SYMBOL	DESCRIPTION	DATE	APPROVED
B	ADDED BLDG 274	7/0/88	
A	SOLED FOR 10% COMPLETE REVIEW	6/17/88

Stearns Catalytic Division of United Engineers & Constructors Raytheon		UNITED STATES ARMY TRAINING CENTER AND FORT DIX DIRECTORATE OF ENGINEERING AND HOUSING FORT DIX, NEW JERSEY 08640	
DRAWN: S. GORMAN DESIGNED: M. MCENAMIN CHECKED: J. J. J. / G.E. S. / S. PP&P DIV: B.F. B&G DIV: UTL DIV: USING AGENCY: ALL		SIEVERS - SANDBURG U.S.A.R.C. PEDRICKTOWN, N.J. BUILDING-273 & 274 UPGRADE OF HEATING/VENTILATING SYS	
RECOMMENDED: <i>[Signature]</i> Chief Engineering, Plans & SERVICES		SCALE: AS NOTED	DRAWING NUMBER: M-5
APPROVED: <i>[Signature]</i> Director of Engineering & Housing		DATE: JUNE 17, 1988	SHEET: 5 OF 11
PR. NR. 28-000030-71

BOILER RM. FLOOR PLAN BLDG 273
SCALE: 1/8" = 1'-0"

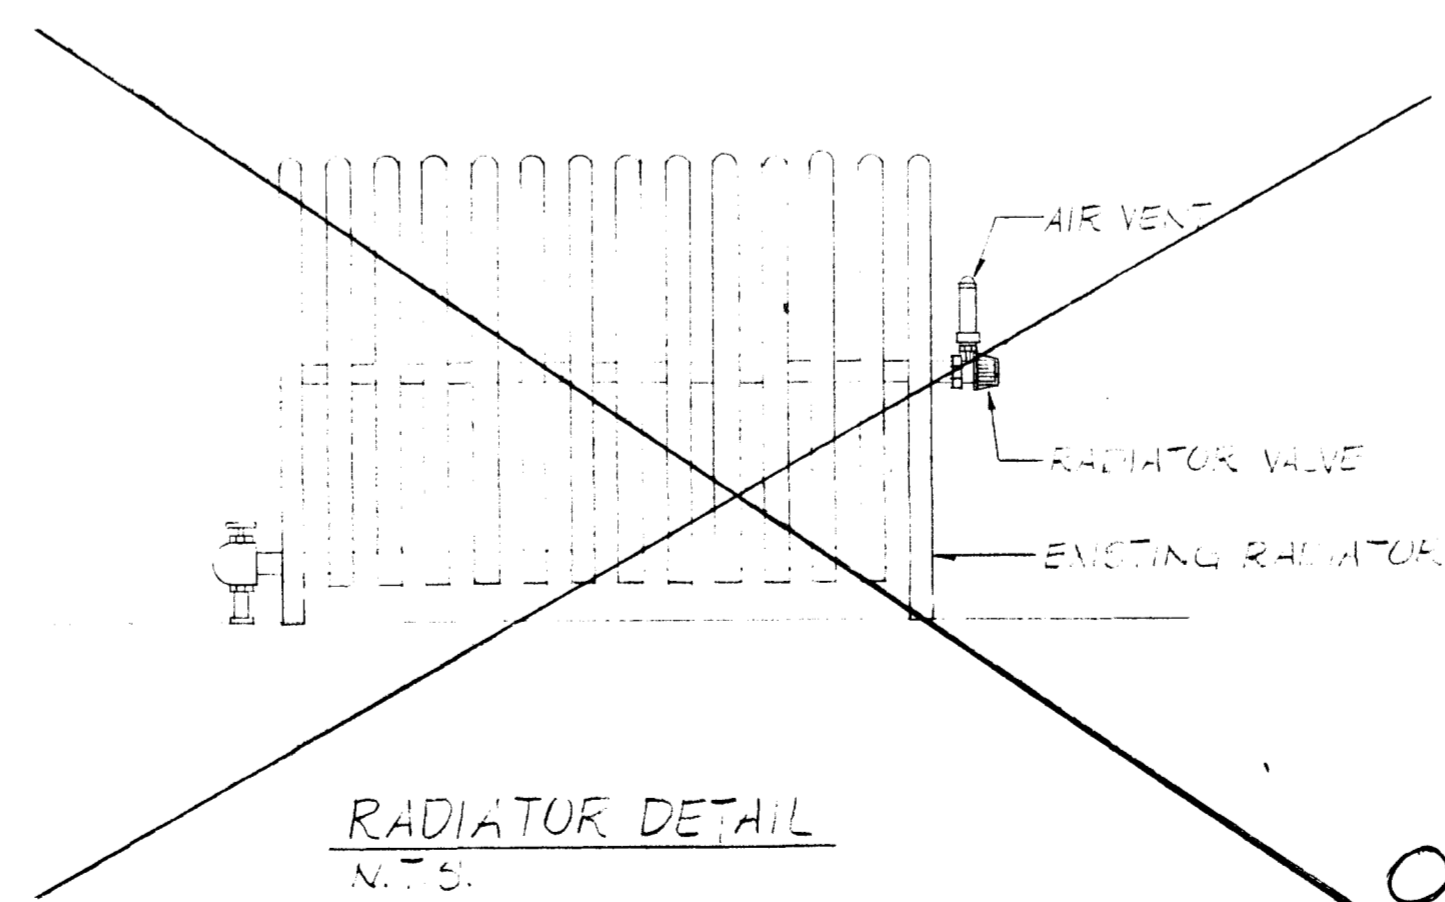
- LEGEND**
- (1) FILL OIL TANK ENCLOSURE AROUND EXISTING OIL TANK WITH SAND TO MAXIMUM 1" ABOVE TOP OF TANK.
 - ~~(2) REMOVE EXISTING 1/2" AIR VENT PROVIDE ONE (1) PER TANK, SEE DETAIL FOR STAINLESS STEEL AIR VENT WITH INTEGRAL VACUUM BREAKER AND METAL CONNECTION. ALL PIPING SHALL BE 1/2" DIA. ALL VALVES SHALL BE DANFOSSE VALVES OR APPROVED EQUAL.~~

- OMIT**
